REQUEST FOR BIDS

Hall Road Drainage Improvement Project - DR-4232-0072

RFB 25BCP08A

ADDENDUM #1

LAYOUT - 2-8' SPAN x 6' HGT. BOX CULVERT

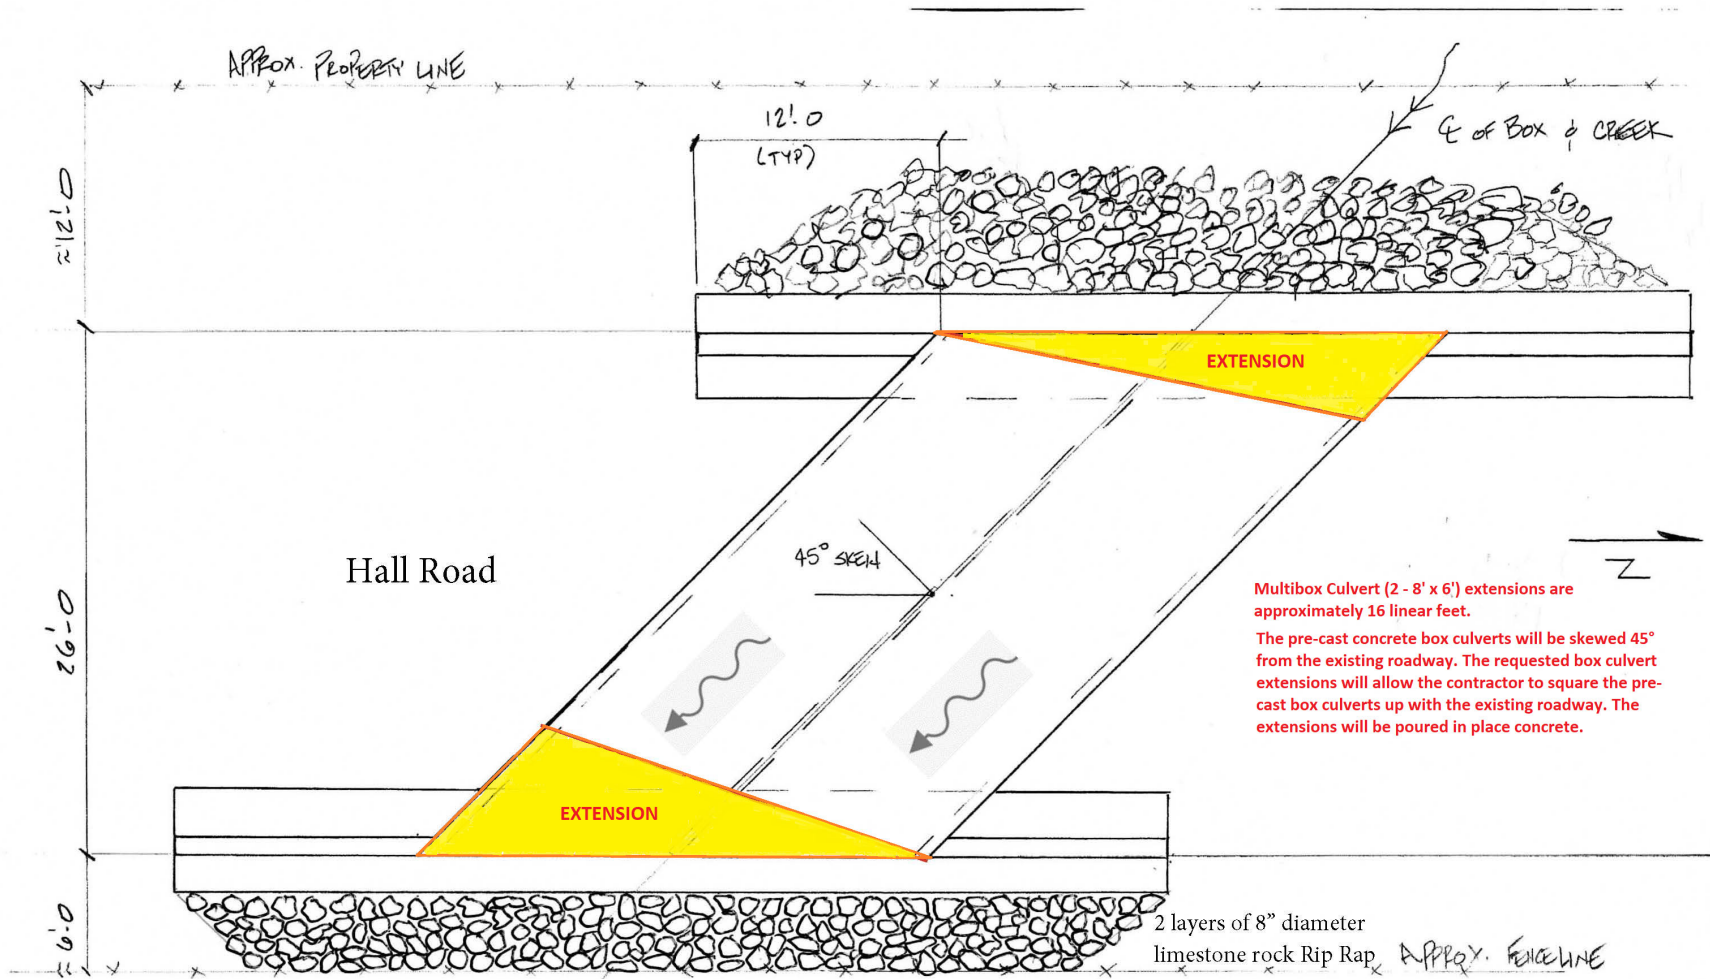
Q: The bid sheet calls out two 8' x 6' feet culvert extensions for a total of 16 linear feet, where do these extensions go in the plans?

A: The extensions are poured in place concrete used to square up the skewed pre-cast concrete box culverts with the existing roadway. See attached drawing for reference.

1. Bastrop County will provide Flow-Line elevation benchmark.
2. Bastrop County will locate Upstream Centerline of Boxes.
